ANCHOR BOLT SETTING PLAN
(BOTTOM OF BASE PLATE ELEVATION: (-1'-10") (U.N.O)
(REF:S1.1)

07/24/2020			ISSUE FOR APPROVAL
DATE	NO.		DESCRIPTION
REVISIONS

INTEL PLAN
(REF:A1.02A,A1.01)

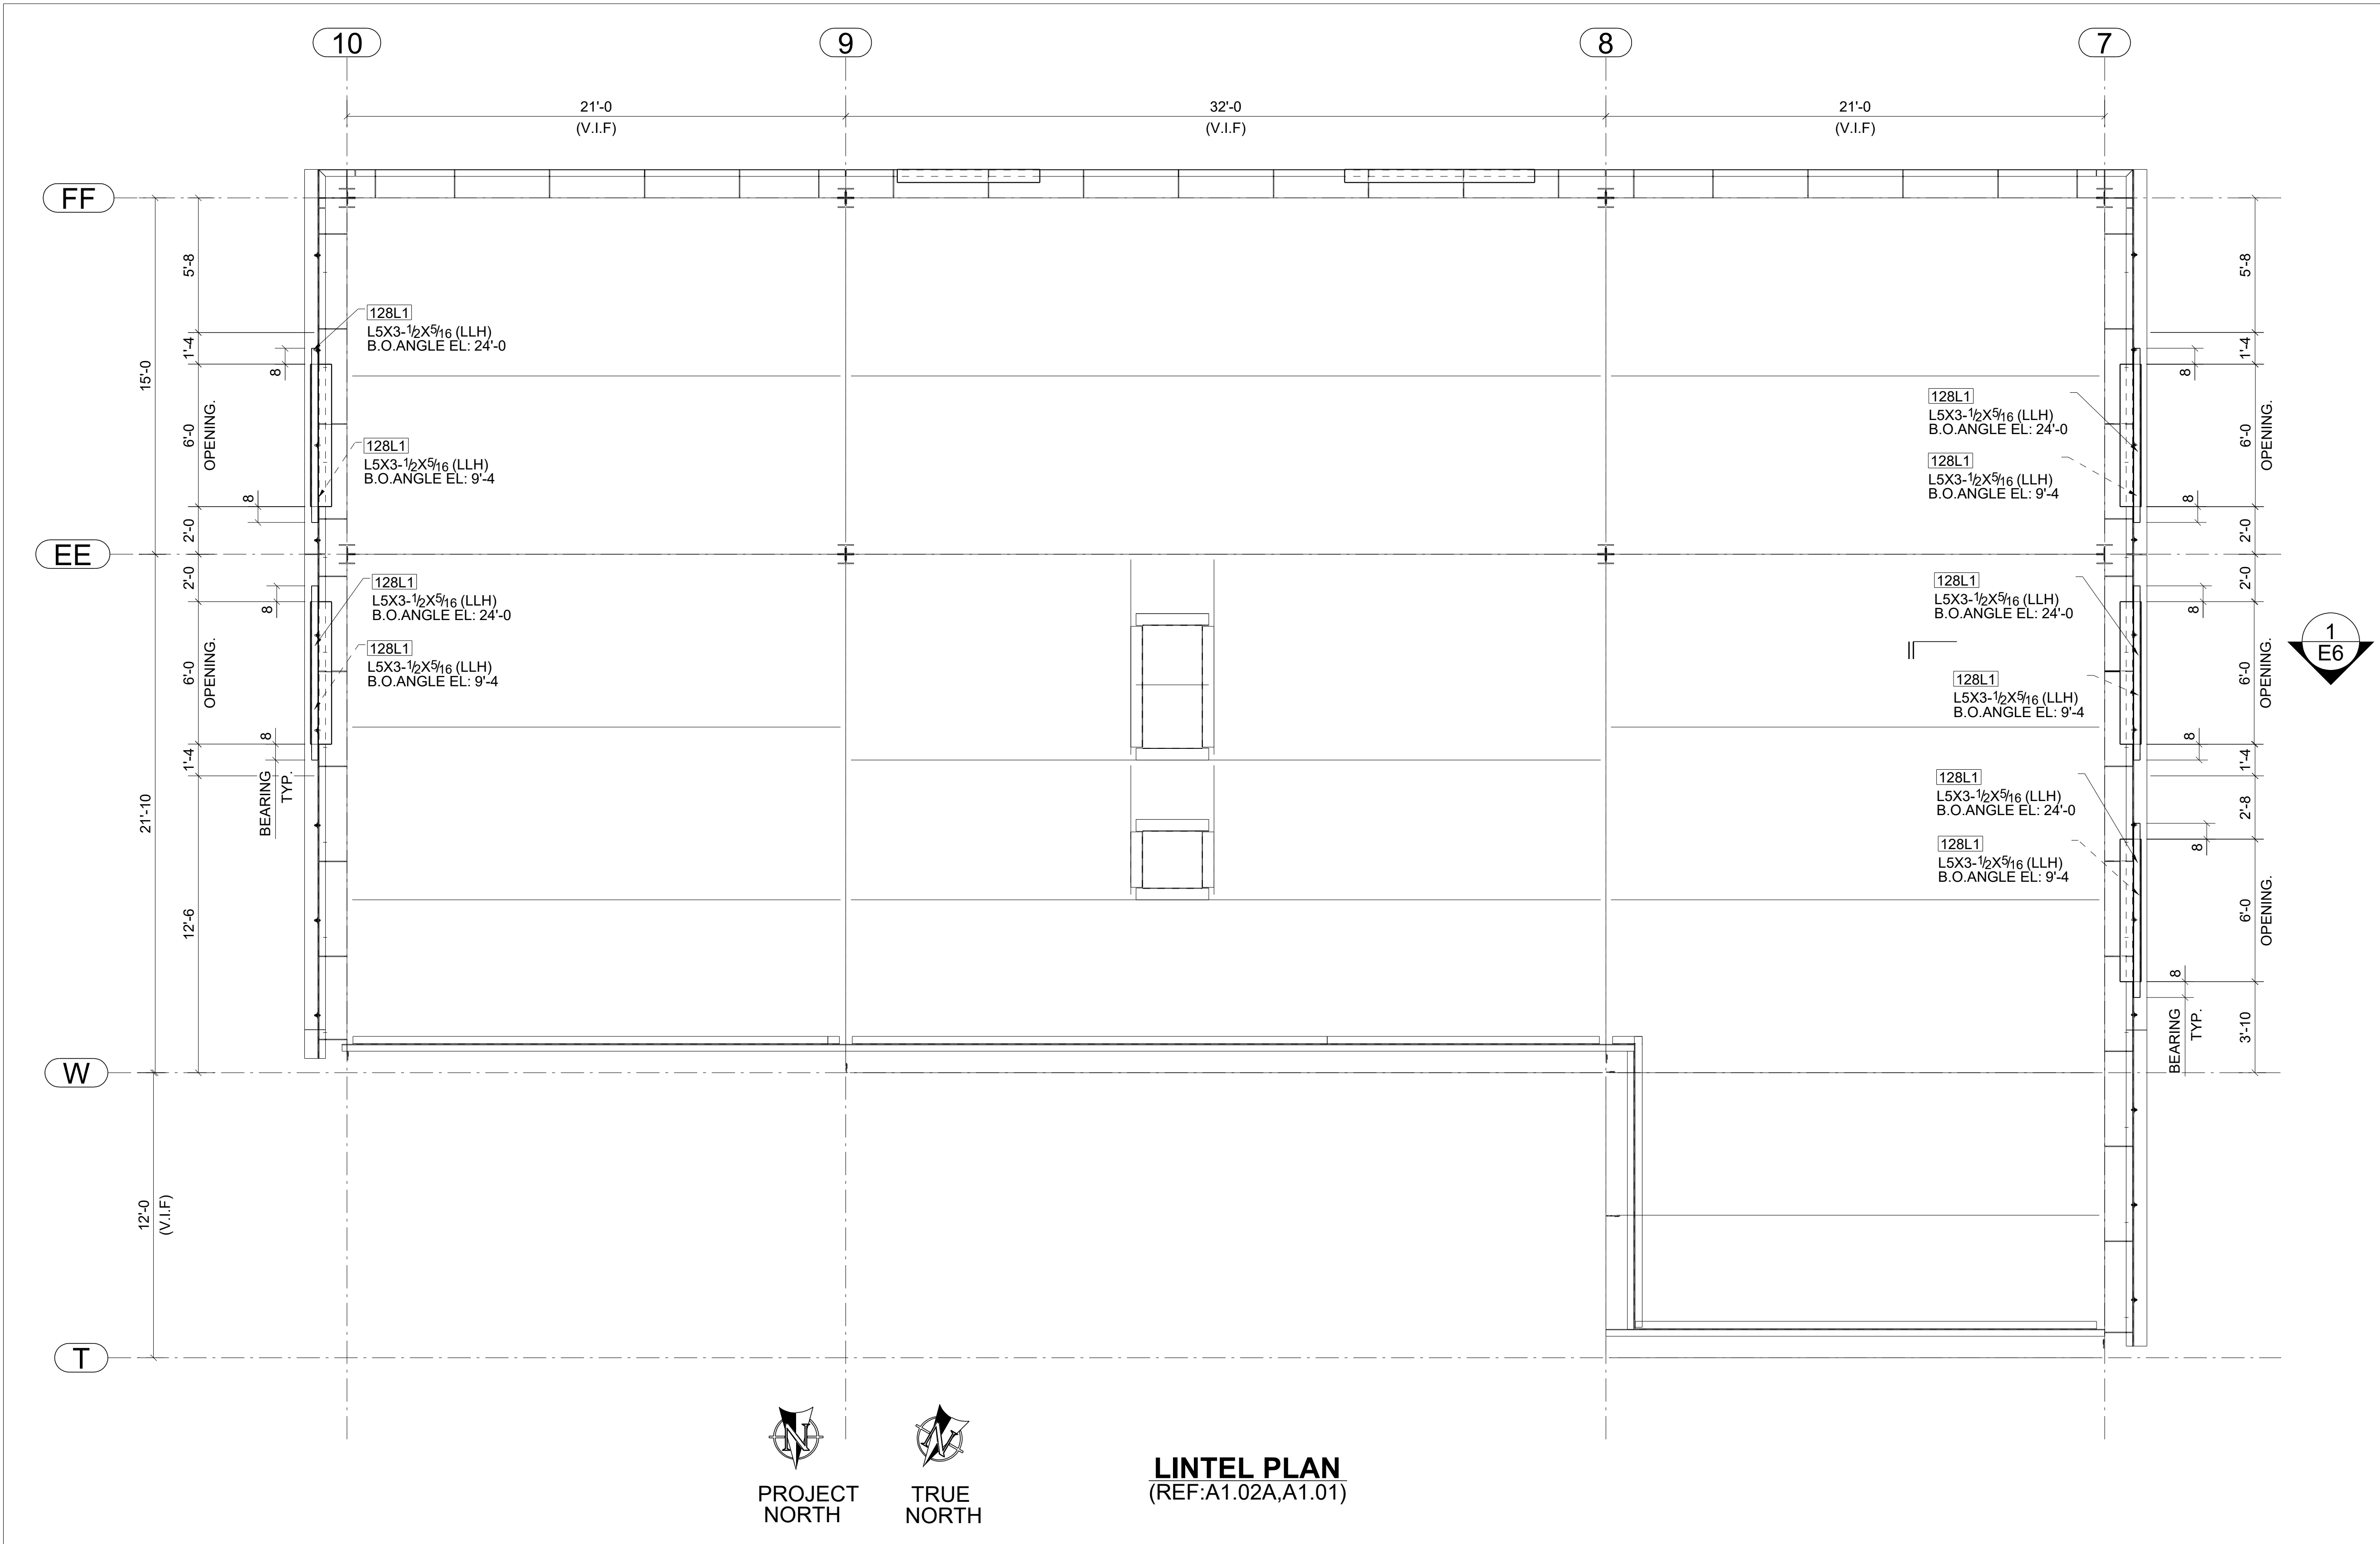
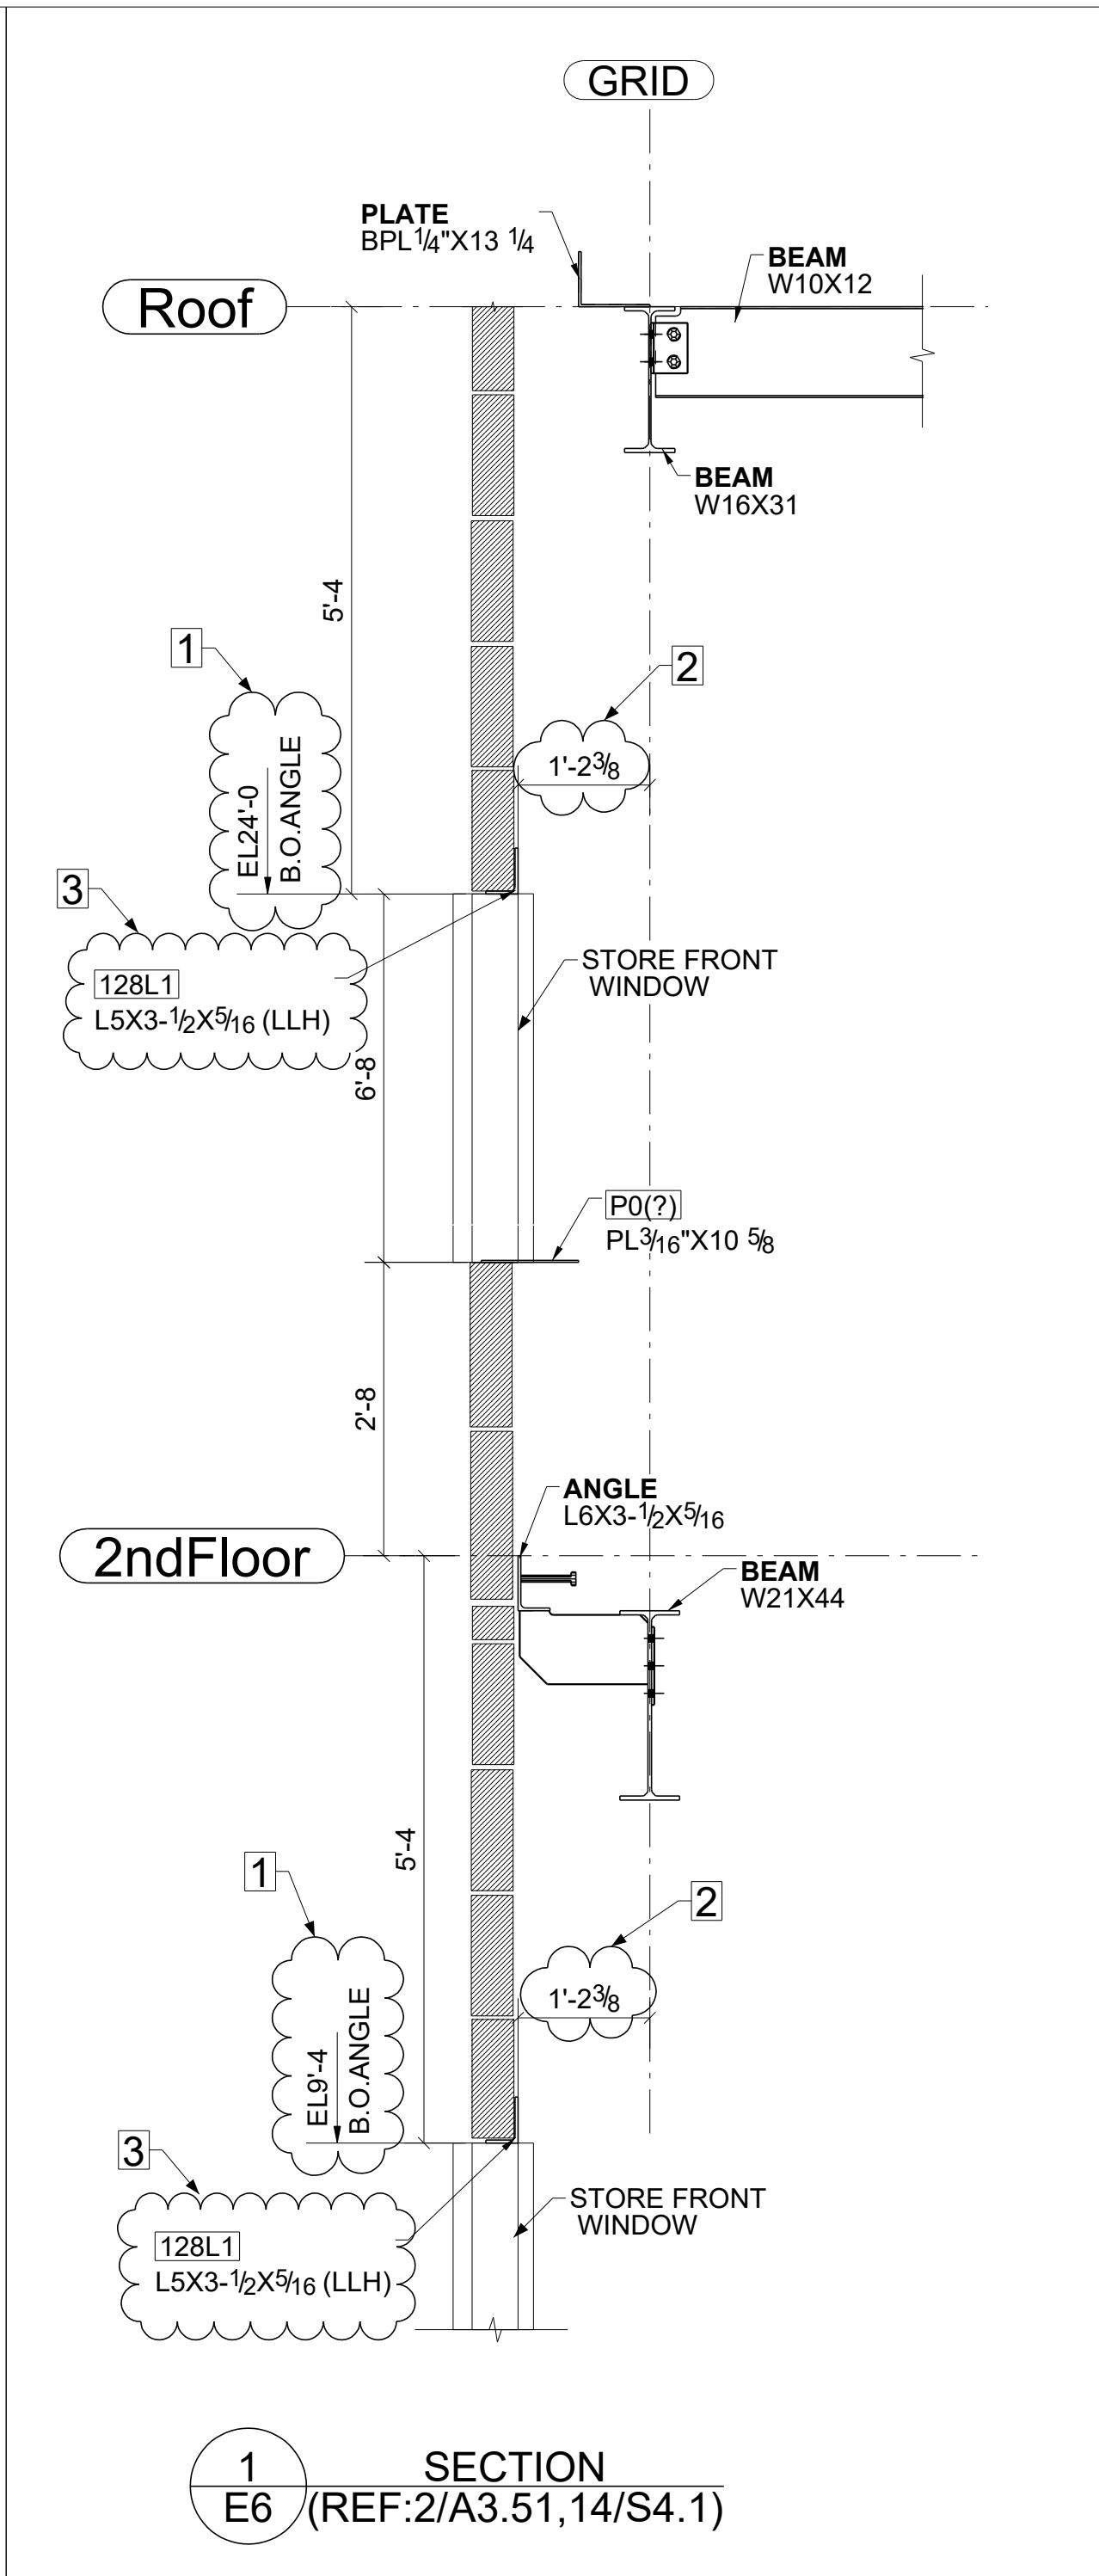
- 1 PLEASE REVIEW AND CONFIRM THE CLOUDED BOTTOM OF LINTEL ANGLE ELEVATION FOLLOWED.
- 2 PLEASE REVIEW AND CONFIRM THE CLOUDED BACK FACE BRICK VENNER LOCATIONS FOLLOWED.
- 3 PER 14/S4.1, THE LINTEL ANGLE PROFILE IS SHOWN AS L7X4X3/8(LLH) BUT WE HAVE FOLLOWED AS SHOWN IN LOOSE LINTEL SCHEDULE AS L5X3 1/2X 5/16(LLH) INSTEAD OF LLV PER SCHEDULE PLEASE REVIEW AND CONFIRM.
